AQUIND INTERCONNECTOR

Day Lane Technical Note

Document Ref: 7.9.29

Aquind Interconnector - Revised HGV Construction Management Strategy for Day Lane

AQ-UK-DCO-TR-LAY-011

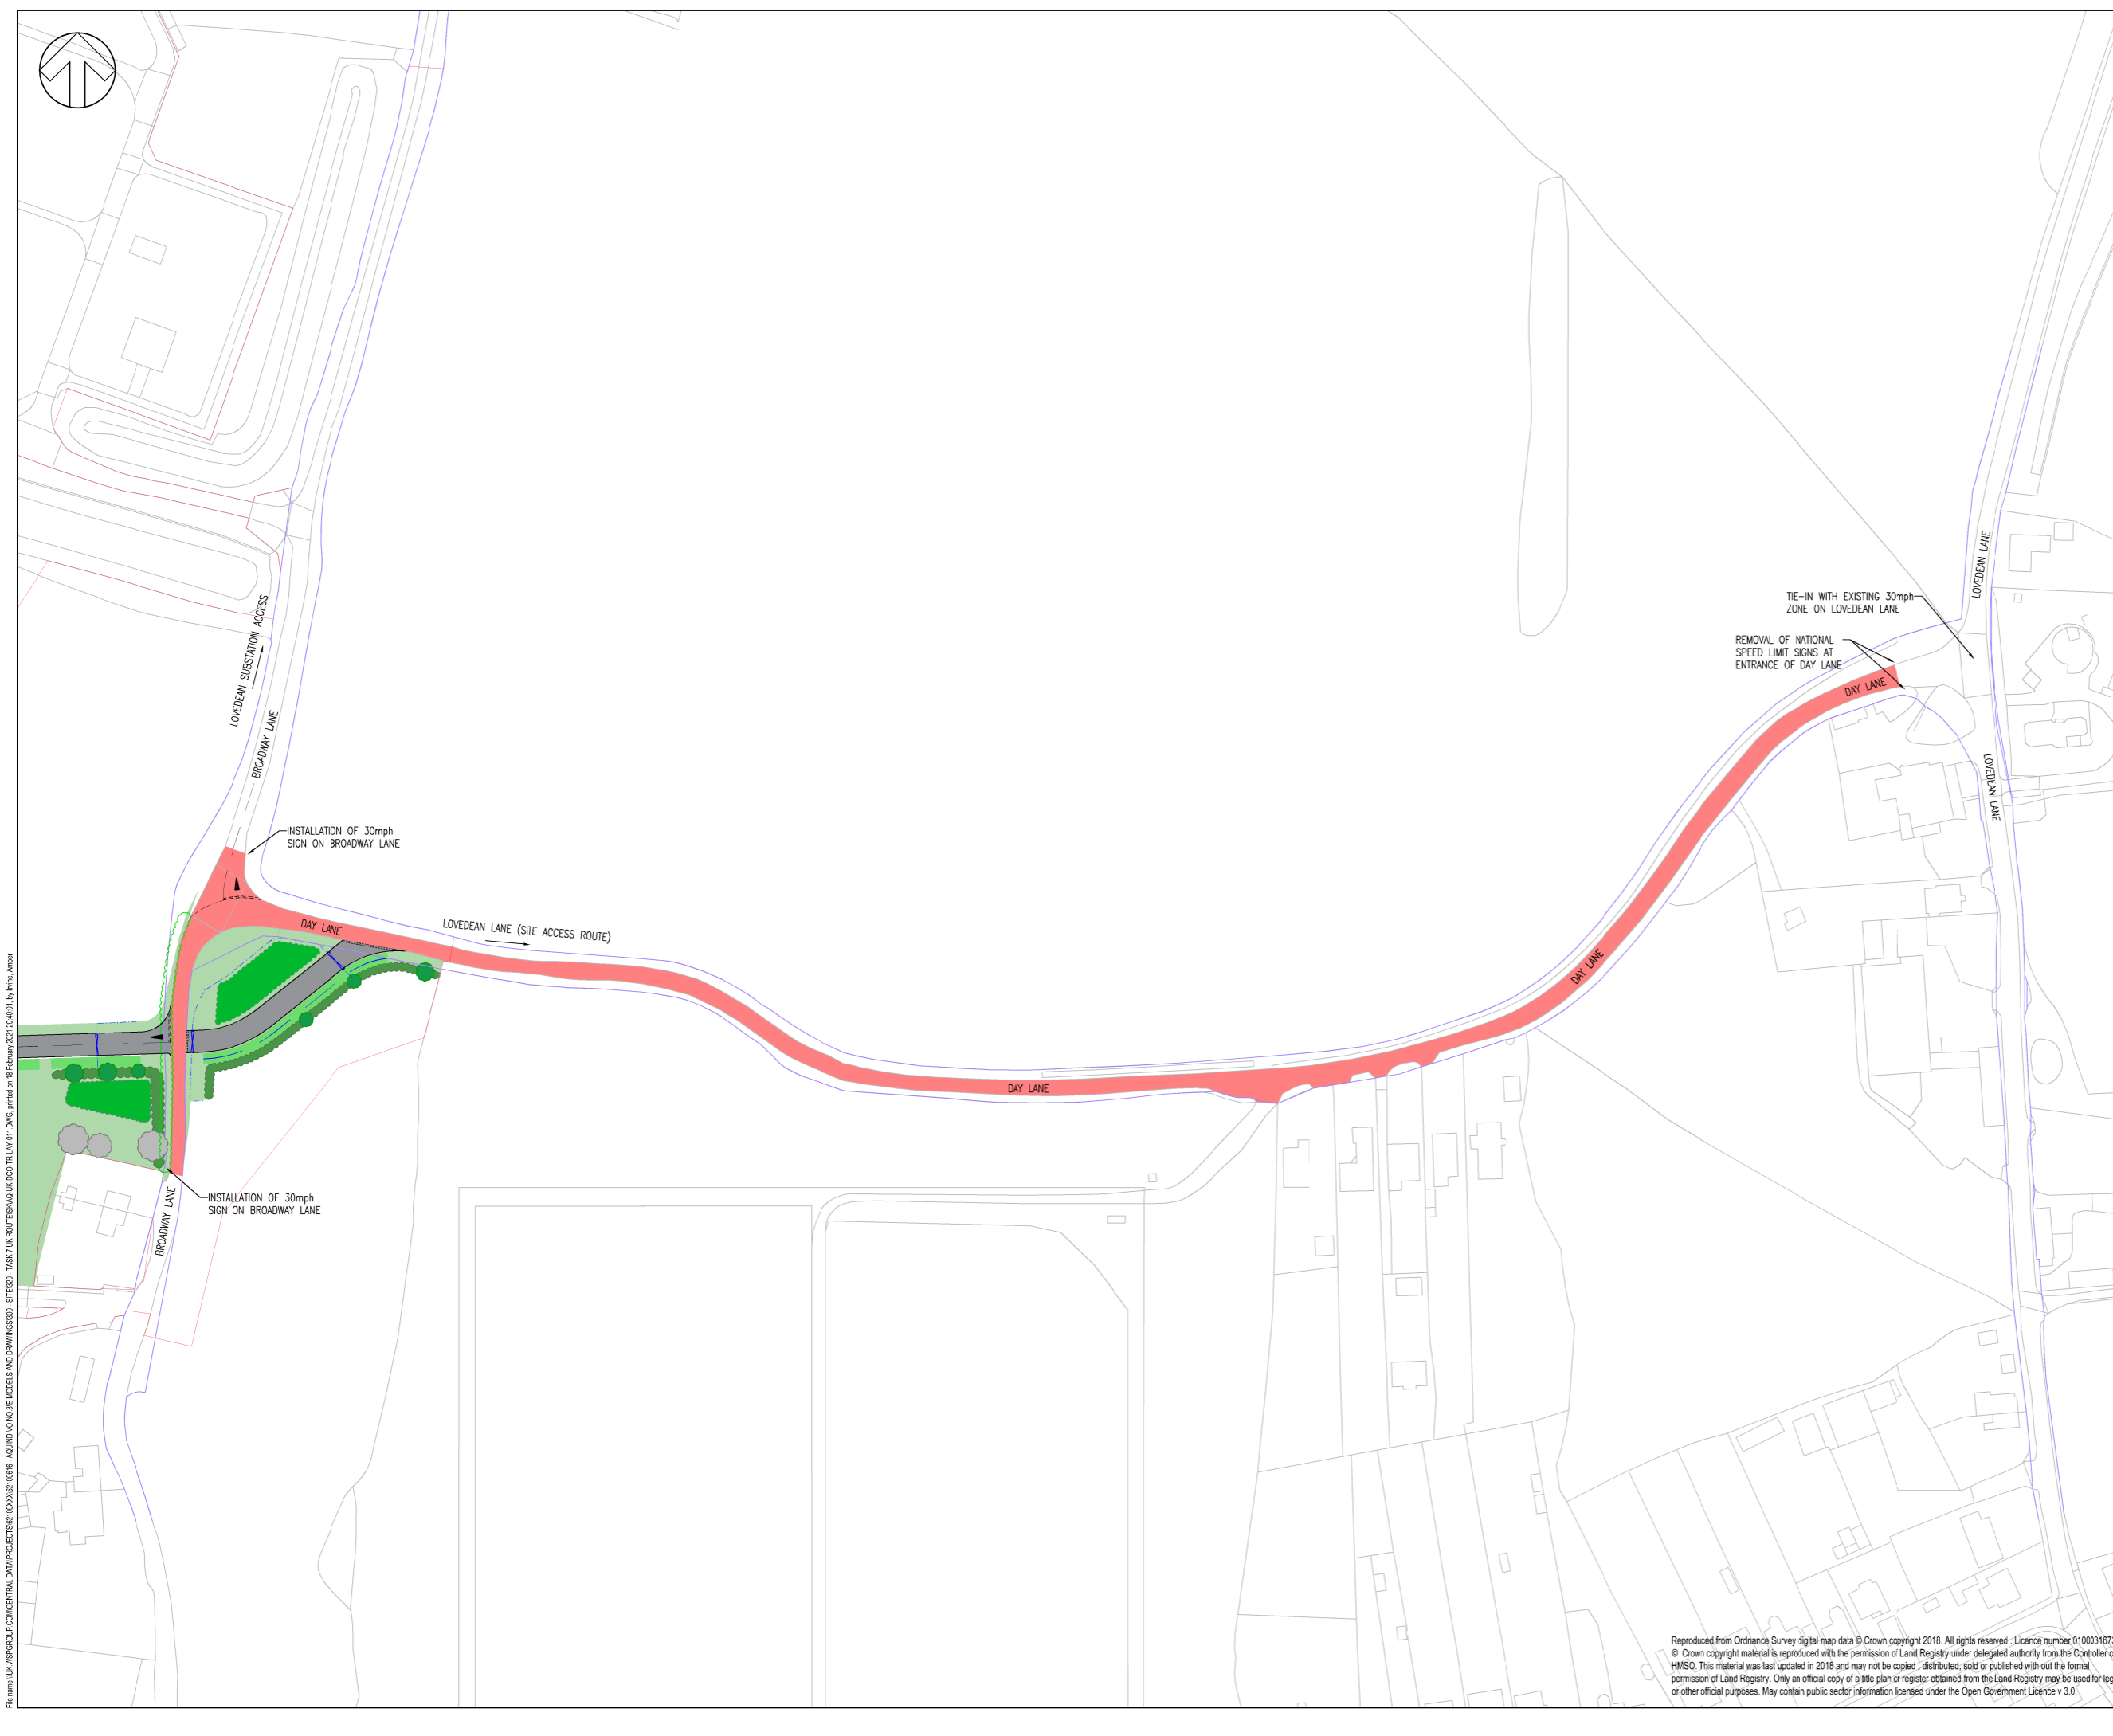
2.6.2. In addition, the Highway Authority have confirmed that Day Lane should be subject to a 30 mph speed limit during the course of the construction of the Converter Station. The extents to which this 30mph speed limit would apply is shown on Drawing AQ-UK-DCO-TR-LAY-011 included in Appendix C.
